Public Service
Company of Colorado

March 5, 1996
Fort St. Vrain
P-96009

**SUBJECT: Response to NRC Questions Regarding PSCo's Proposed
Revisions to Final Survey Plan For Survey of Piping Systems
and Suspect Affected Survey Units**

Attachment to P-96009

Figure 1 - Down Facing TLD Centered in Pipe With Defined Field of View

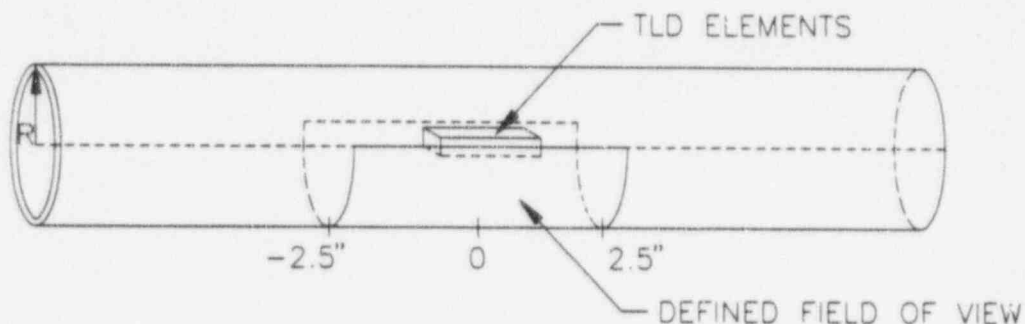
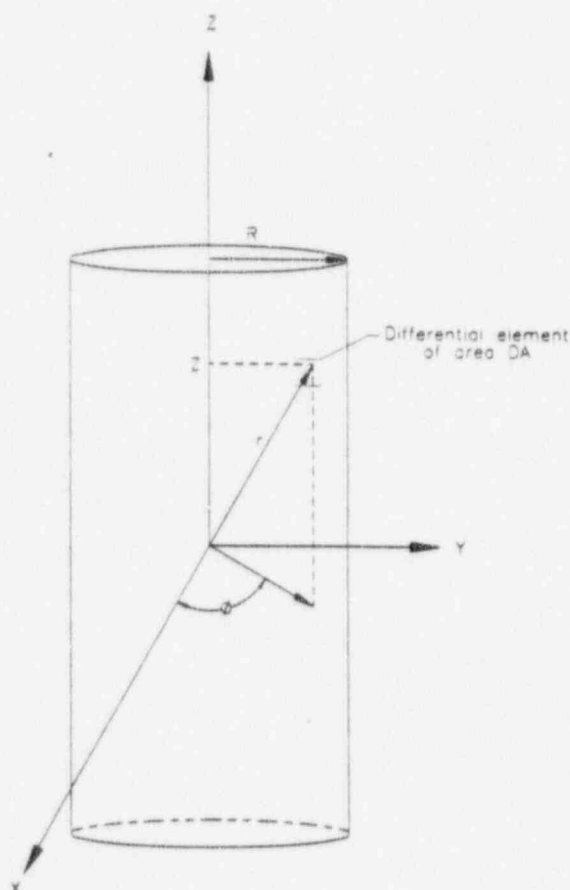
NRC Comment No. 10: Regarding TBD-203, Page 4, Paragraph 2:

This evaluation is performed to estimate the response of a TLD centered in a small diameter pipe to highly localized contamination (i.e., a point source). An Inverse Square model was used to estimate the relative response from a point source located at various positions relative to the centered TLD. It is recognized that this is a simplified model that does not incorporate all factors that could affect the overall response of a TLD to a localized source. However, since an inverse square reduction with increasing distance is a dominant factor, it is considered useful to provide a reasonable estimate of relative TLD response to a point source. Using this model, maximum over and under response factors and the fraction of total response to the TLD for various field of views are determined.

As mentioned, the TLD's relative response to localized contamination is determined by an inverse square relationship. For example, a "point" detector located 1" from a point source would have four times the response of a detector located 2" from the source. To illustrate the possible distances that a point source within a defined field of view could be from a TLD, Figure 1 below is provided. As shown in the figure, the defined field of view, which is shown only for a down-facing TLD, is about 5" by 1/2 the pipe circumference. For 1 inch diameter piping, this is equal to approximately 50 cm² and for 2 inch diameter piping about 100 cm².

To determine maximum over and under response factors, the effective distance of the calibration source must be determined. The effective calibration distance is the distance from the TLD that a point source equal to the total activity of the distributed calibration source would be from the TLD in order to produce the same response produced by the calibration source. To calculate this distance, cylindrical geometry is used as shown by Figure 2 below.

The TLD's response to a point source at a given distance r is proportional to $1/r^2$. The amount of surface activity at a given differential element of a uniformly distributed source is proportional to the area (dA) of the element, where $dA = R d\phi dz$. Total response of the TLD from the distributed source is equal to the sum of responses from each differential element. As the differential element size goes to zero the sum becomes an integral as shown below:
